United States Army Fort Monmouth, New Jersey

Army Response to N.J. Department of Environmental Protection Correspondence Letter Dated October 28, 2008

Re: Army's Response to NJDEP correspondence (Dated October 28, 2008), Draft Site

The U.S. Army Fort Monmouth has reviewed the subject comments as submitted by the NJDEP on 28 October 2008, in regards to the Draft Site Investigation Report dated July 21, 2008 by Shaw Environmental Inc. Referenced below is a line by line response in bold print, to each comment and request for an "No Further Action" (NFA) determination where appropriate.

ATTACHEMENT G

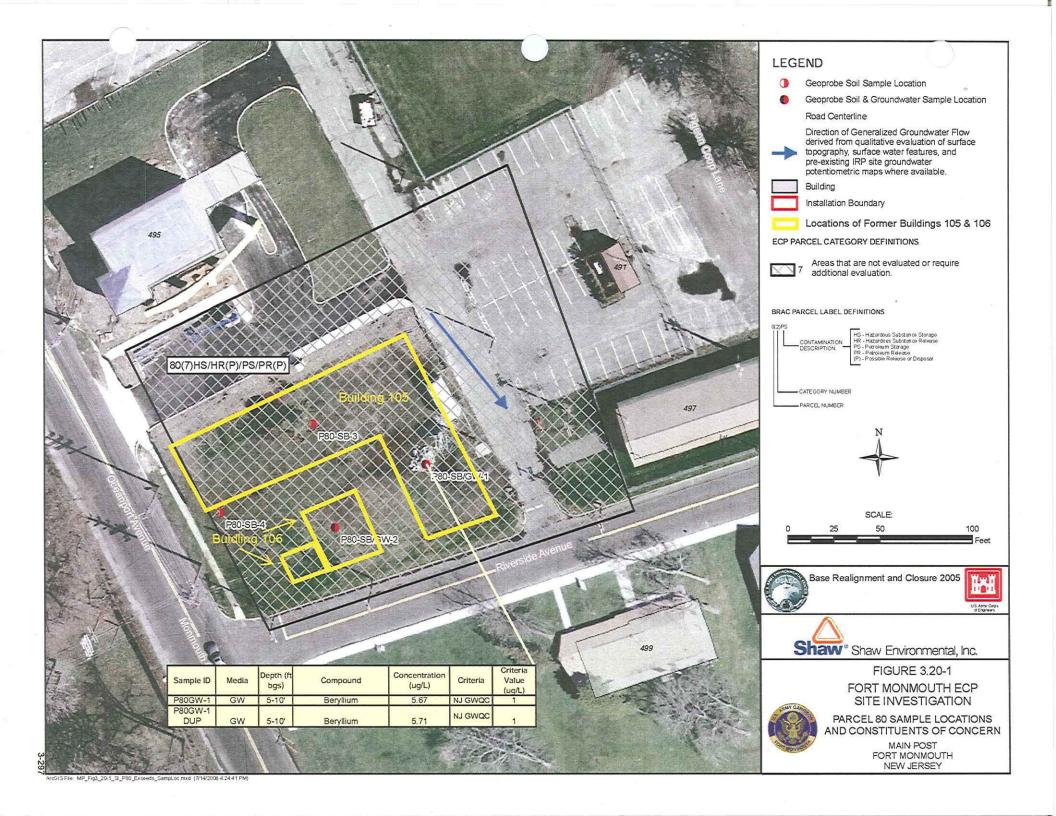
1. The footprint of the former building 105 and 106 should be shown on Figure 3.20-1. On the current Figure, it cannot be determined where the former buildings were located in relation to the Geoprobe borings, so NFA for soil cannot be approved.

A figure depicting the approximate locations of former buildings 105 and 106 in relation to the soil borings is attached at Attachment G.

ATTACHMENT H Parcel 83 former Structures Map.

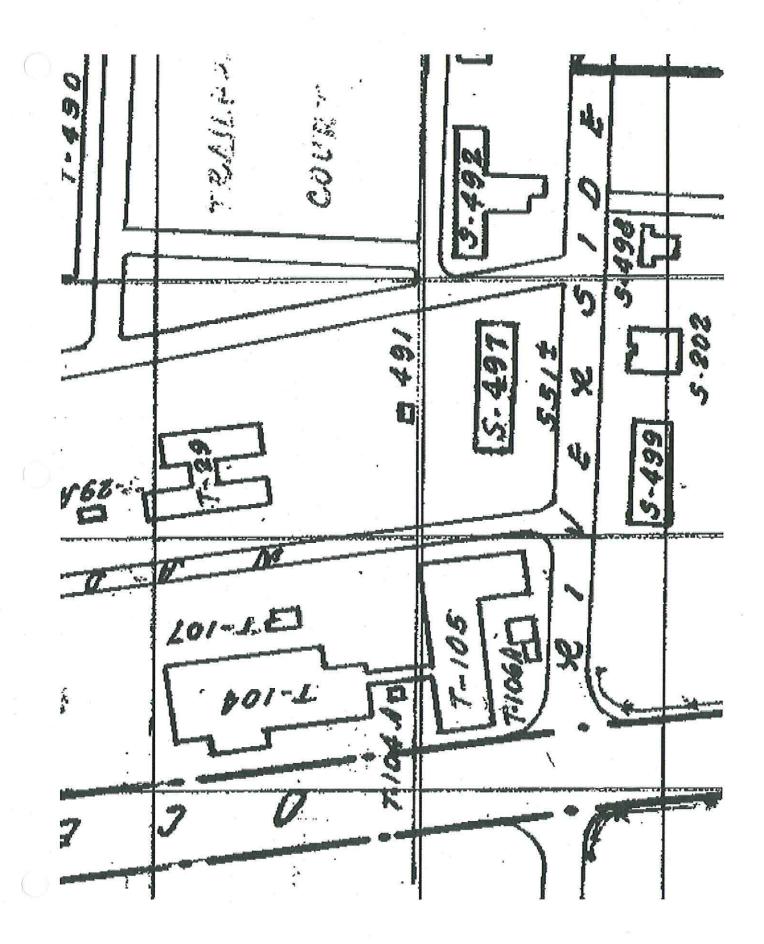
1. Former structures, buildings, and other areas of concern are discussed in the text and in the tables but are not indicated on the Figure 3.21-1. All areas of concern, whether existing or former structures, must be depicted on the site figures.

A figure depicting the approximate locations of former structures at Parcel 83 is provided at Attachment H. This map can also be found in the ECP Phase I – Appendix O.
